RE: Lot 3 Block 10 Unit 22, S.A.D. 228 6424 Petirrojo NW Grading and Drainage Plan Engineers Stamp Date 5-10-18 (D10D003F3)

Based upon the information provided in your submittal received 5/11/18, this plan cannot be approved for Grading Permit until the following comments are addressed

DRAINAGE PLAN

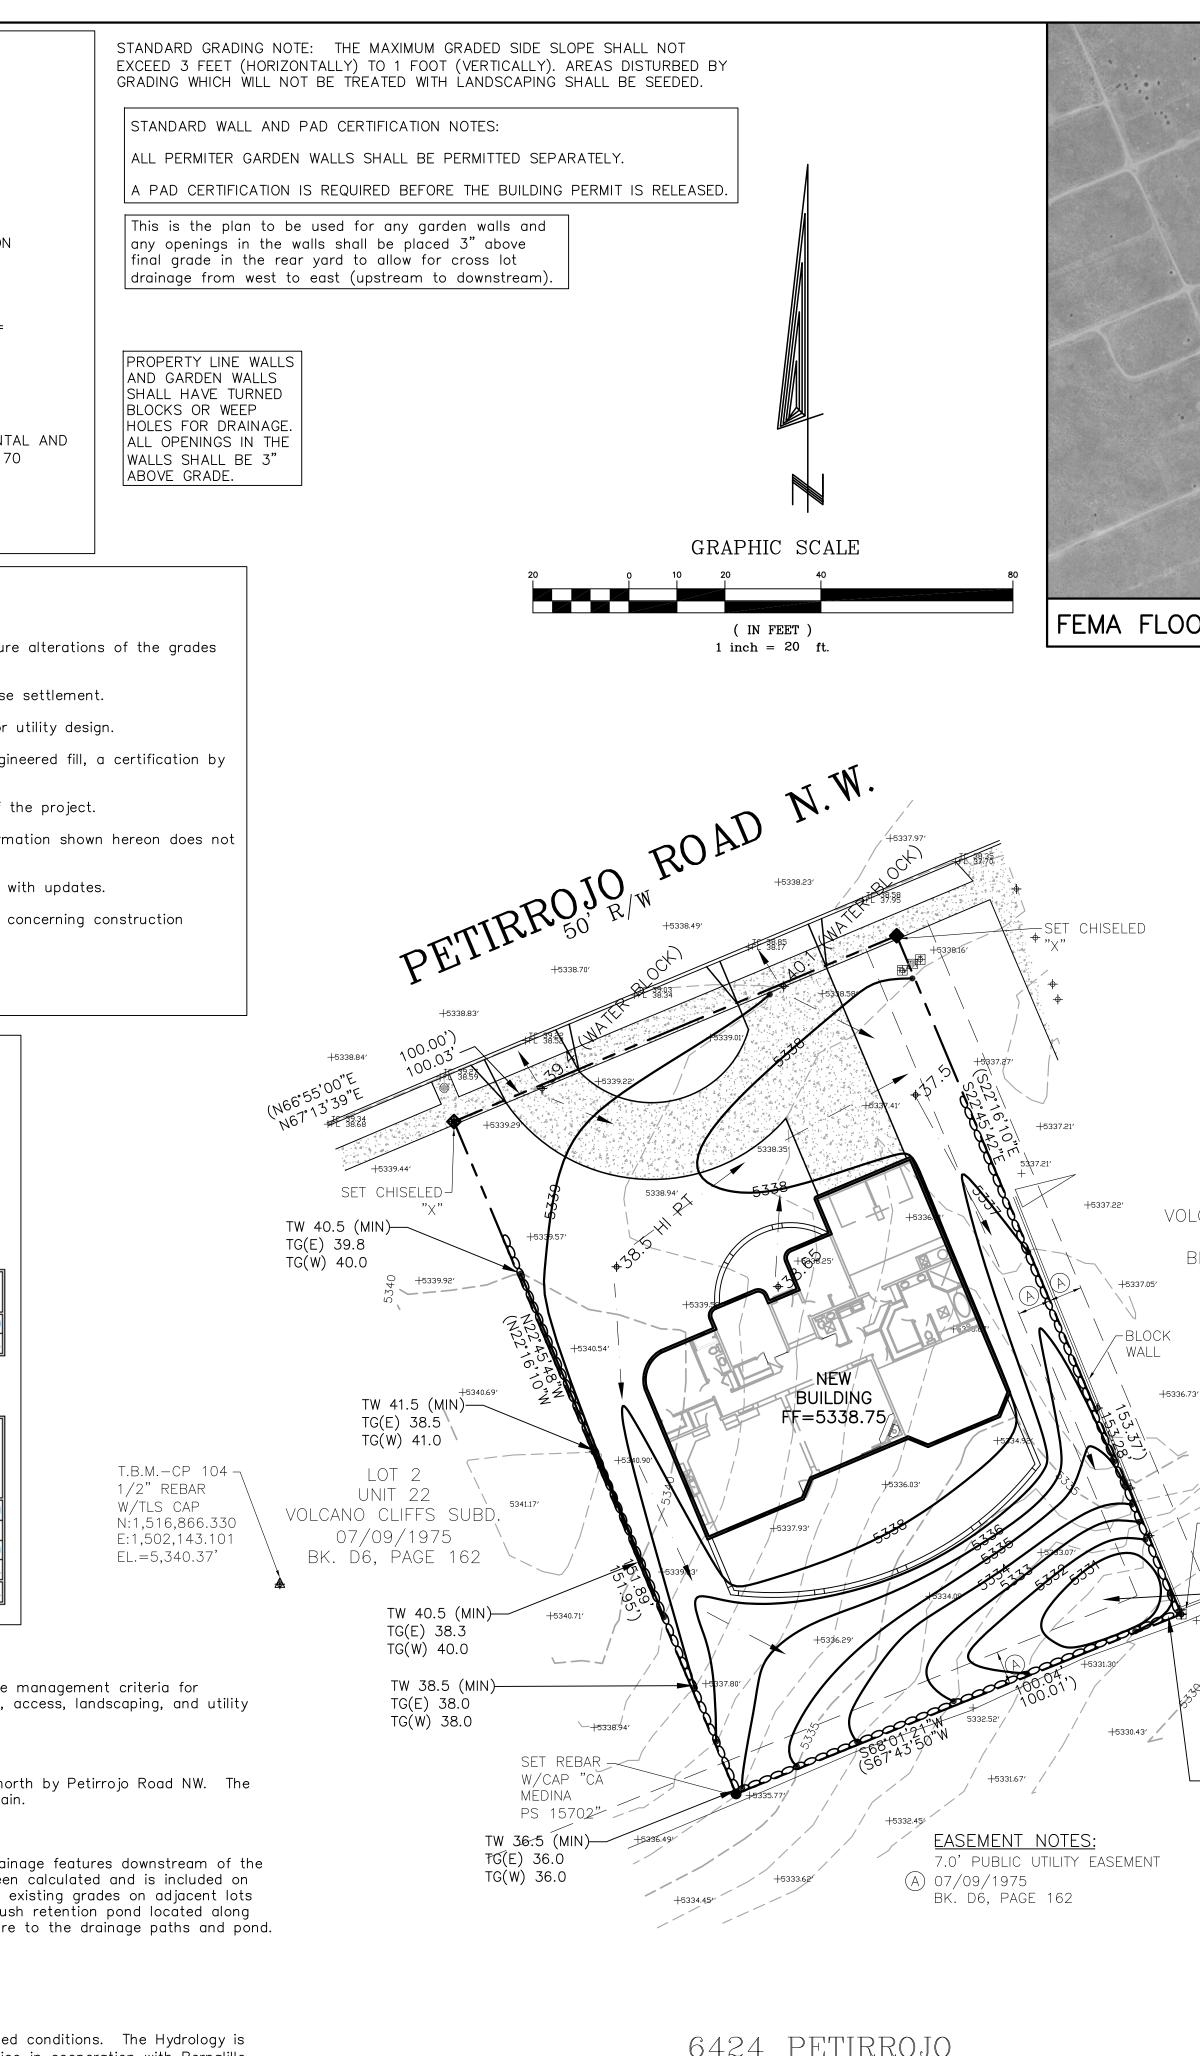
- Provide a cross section of the block walls/fence showing the location of the footing. If the footing is encroaching onto the abutting properties a letter of acceptance will be needed from the property owners for the placement of the footing.
- Provide the size of the openings and calculations for the turn blocks, to show that the openings are sufficient for the passage of the flows required.
